Addendum to the Bidding Documents

Addendum No. 1
June 2, 2020

Horace Mann ES
225 Nevada Street
Newton, Massachusetts

Horace Mann ES
Phase 1 Partition Work

PROPOSED ELEVATION

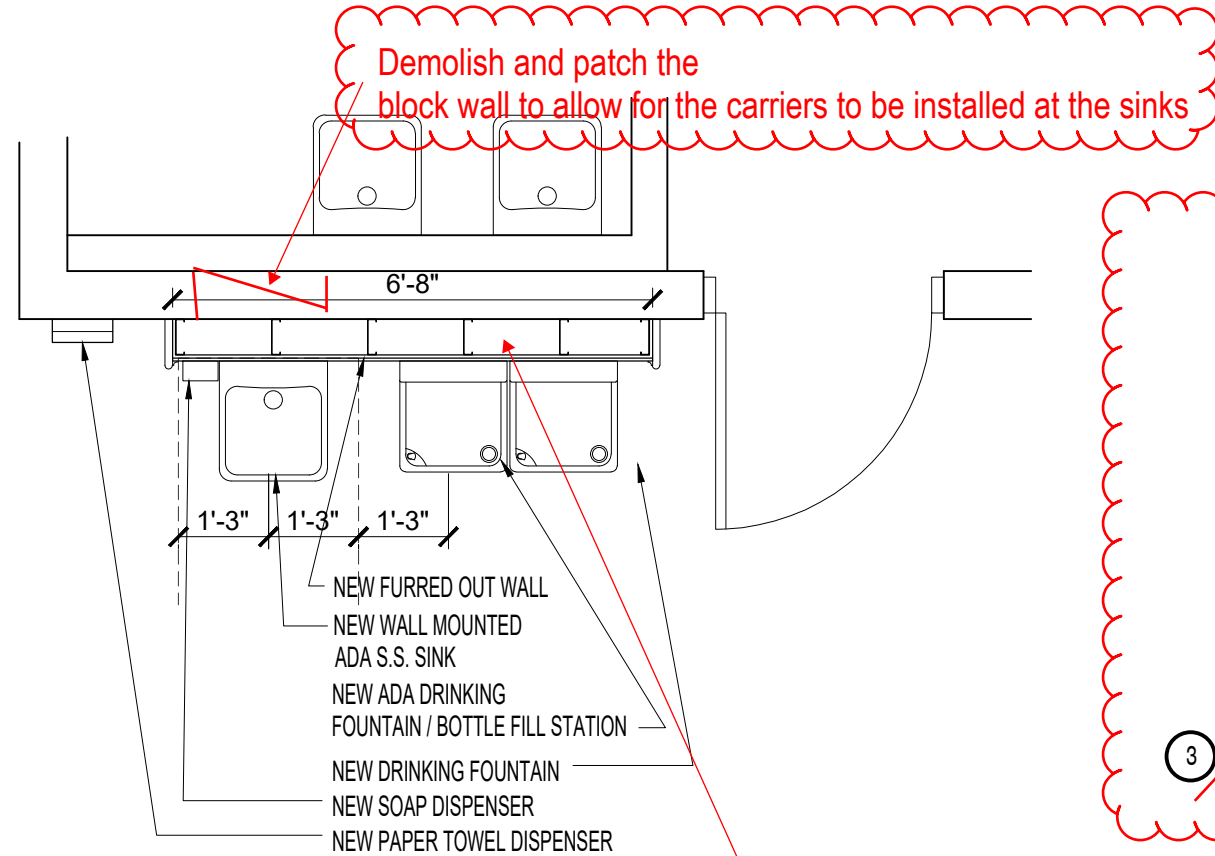
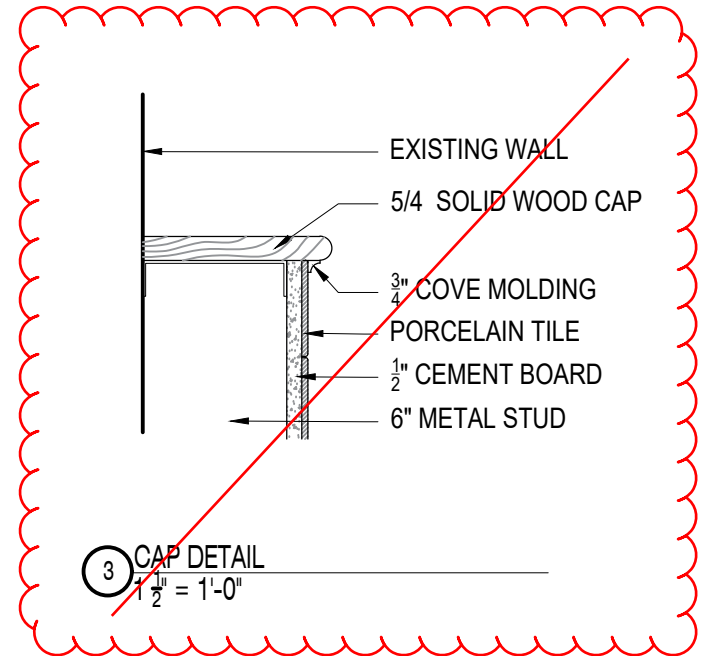
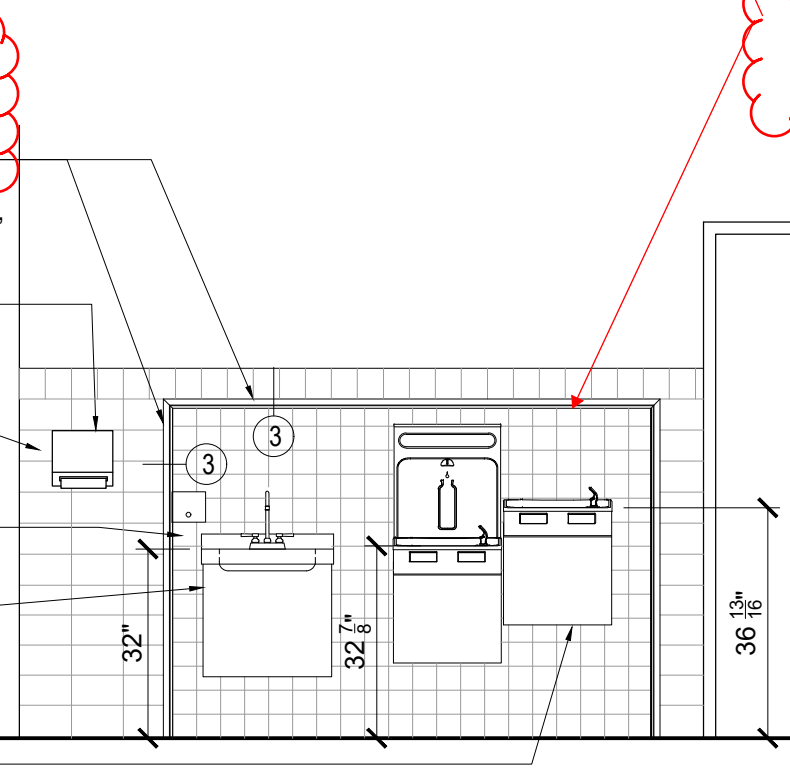
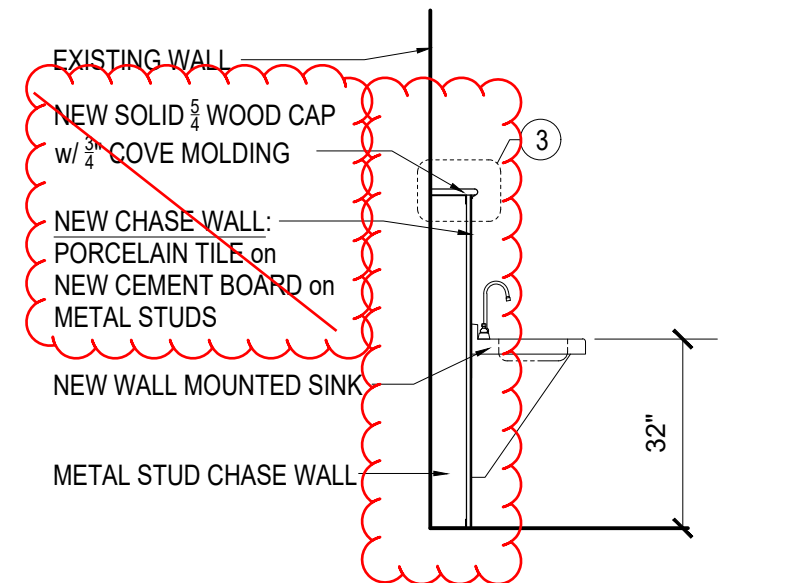
~~NEW SOLID 5/4 WOOD CAP w/ 3/4" COVE MOLDING TO UNDERSIDE OF TOP ROW OF TILE AND DOWN SIDES~~

~~NEW PAPER TOWEL DISPENSER, SUPPLIED BY NEWTON PUBLIC SCHOOLS INSTALLED BY CONTRACTOR~~

~~NEW CHASE WALL: PORCELAIN TILE on NEW CEMENT BOARD on METAL STUDS~~

~~NEW WALL MOUNTED S.S. SINK w/ S.S. SKIRT~~

~~NEW BI-LEVEL ADA DRINKING FOUNTAIN / BOTTLE FILL STATION~~

New chase walls are not required
